Well Name: GALLEGOS CANYON UNIT	Well Location: T29N / R12W / SEC 28 / SESW / 36.69251 / -108.10783	County or Parish/State: SAN JUAN / NM
Well Number: 180E	Type of Well: CONVENTIONAL GAS WELL	Allottee or Tribe Name:
Lease Number: NMSF078209B	Unit or CA Name: GCU DK 892000844F	Unit or CA Number: NMNM78391C
US Well Number: 3004524869	Operator: SIMCOE LLC

Subsequent Report

Type of Action: Plug and Abandonment

GCU Com H 180E
GP/DK
API # 30-045-24869
Unit N - Sec. 28 - T29N - R12W
San Juan, NM

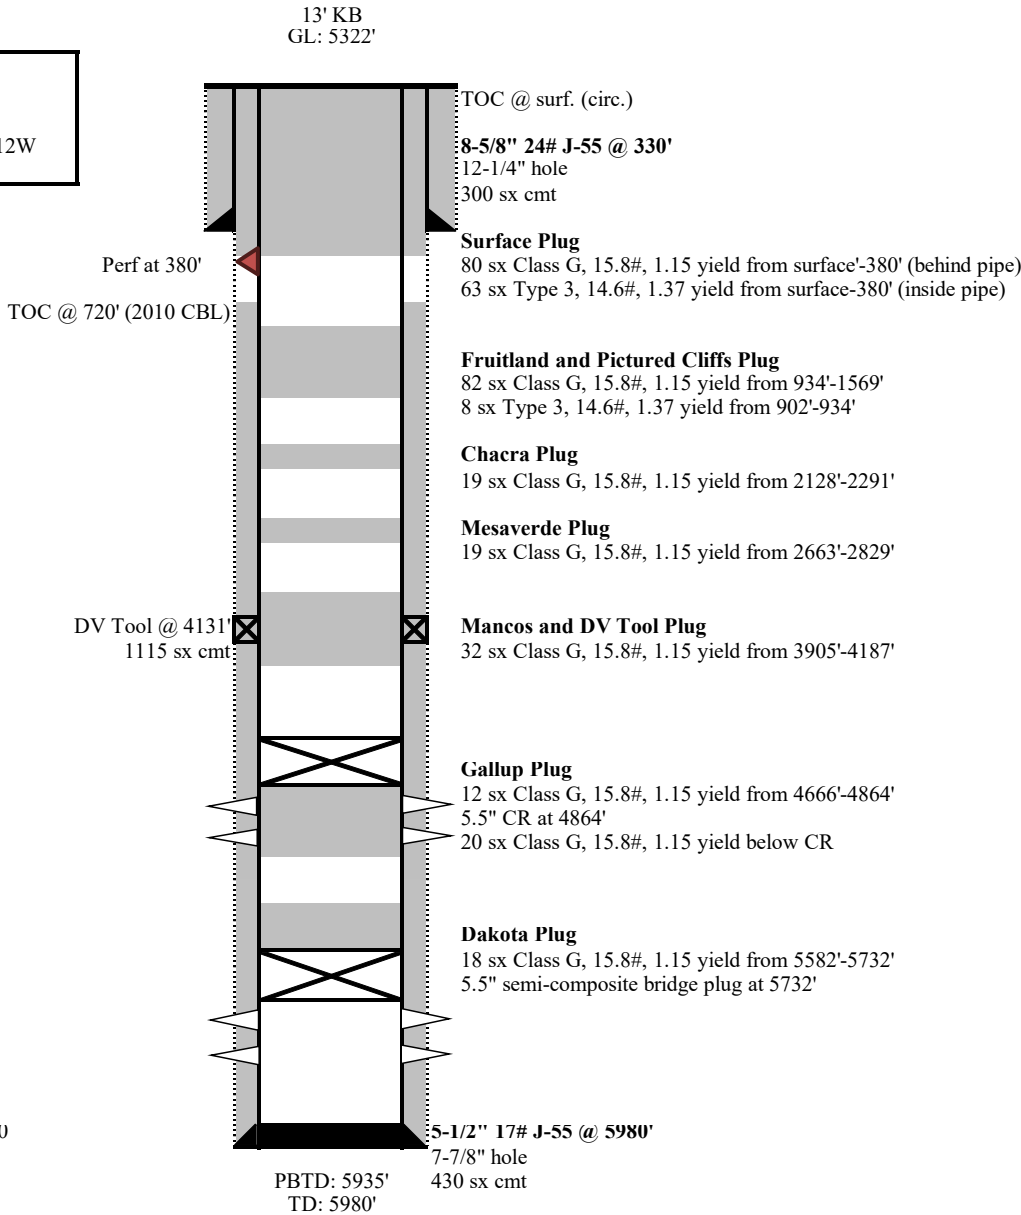
Based on our discussion this morning I wanted to follow up and send the revised wellbore diagram with the changes discussed. This diagram reflects change in the plug at the retainer and Mancos formation. I removed the Menefee/Point Lookout plug and the plug from 650' to 500' that were not required. I also extended the surface plug to 420' for more isolation under the surface shoe.

The BLM finds the existing bridge plug appropriate. And the proposed plug proposals for Dakota/ Graneros Shale and Gallup appropriate.

A formal BLM review is needed for the proposed plugs above the Gallup. Adjustments may be requested.

Note, the BLM Farmington Office does not require coverage for the Point Lookout and the Menefee. BLM does require coverage for the Chacra. The BLM will provide the minimum Chacra plug locations after formal BLM review.

The BLM approves of moving forward with this plan. Make sure that the Fruitland plug is tagged at 905' (50' above BLM Fruitland Coal top) or higher after top off.

On the GCU Com H 180E, we have set plugs all the way through out Fruitland plug. This morning, the bradenhead had 130 psi. Simcoe would like to propose that we eliminate the proposed inside/outside plug from 500-650', perforate at 380' (50' below the surface shoe), and circulate an inside/outside plug to surface. Please let me know if NMOCD and BLM approve this plan.

NMOCD approves below.

The BLM approves of the changes.

NMOCD approves below due to Kirtland top being at 104 feet inside surface pipe.

The BLM approves of the plan.

GCU Com H 180E
GP/DK
API # 30-045-24869
Unit N - Sec. 28 - T29N - R12W
San Juan, NM

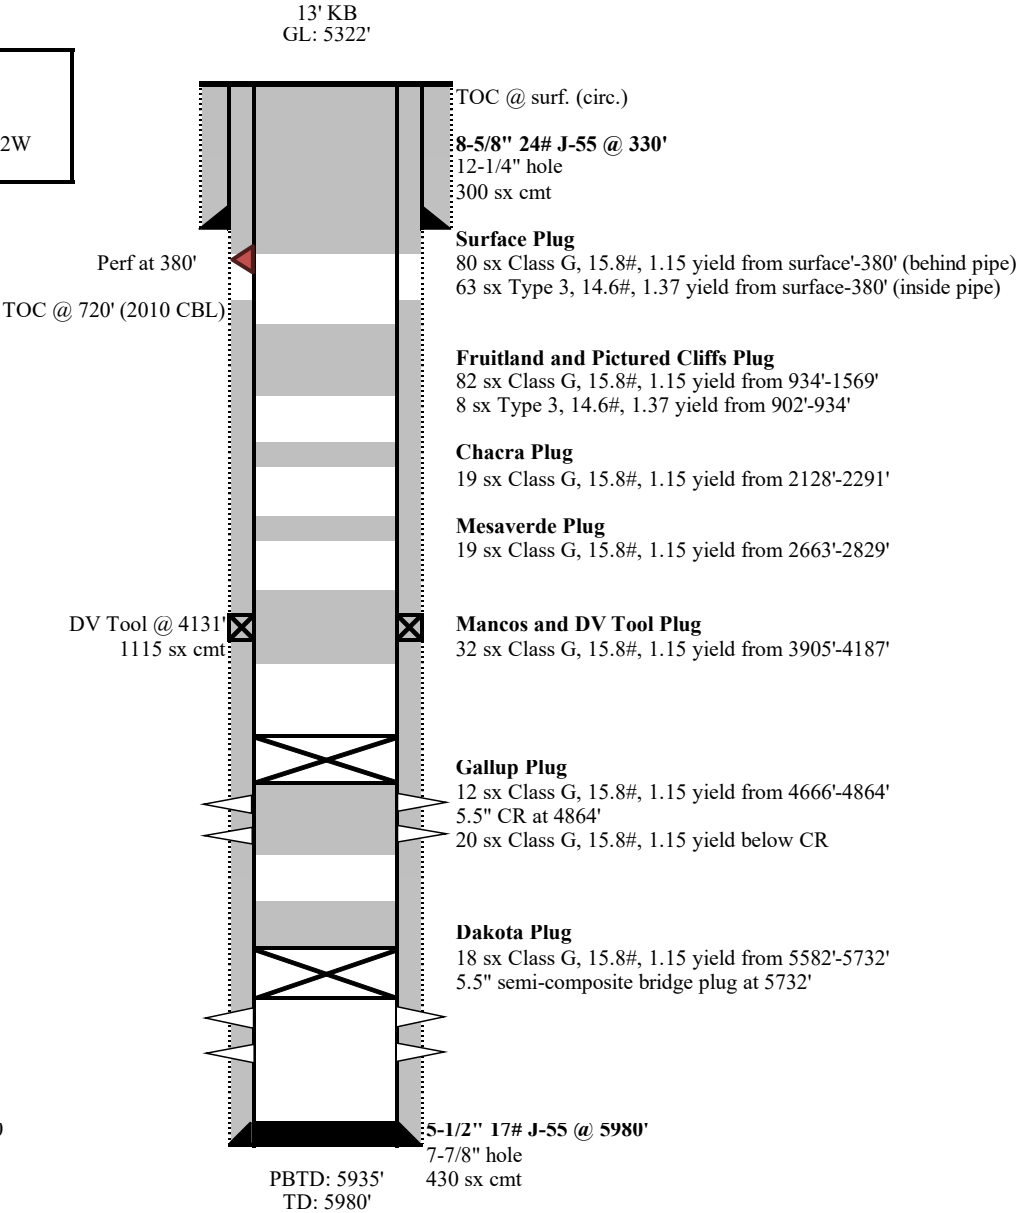
Created By	Condition	Condition Date
mkuehling	Composite bridge plugs are not allowed in pluggings	3/27/2025
mkuehling	CBL in log file - well plugged 2/11/2025 - wrong date for plugging date - should be year 2025	3/31/2025
